Architect's Field Report

18044-Bovina Elementary / Report Number 020

Figure 15 – Edge Trim Protrudes 1/8" +/-

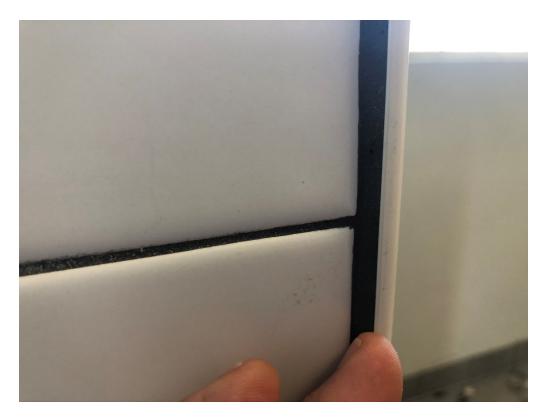
Tile has been completed in these restrooms. Pay attention to figures 15

& 16 in this report as this trim is not correctly seated in the tile.

Figure 16 – Edge Trim Protrudes 1/8" +/-

Reset Metal trim for flush appearance with tile.
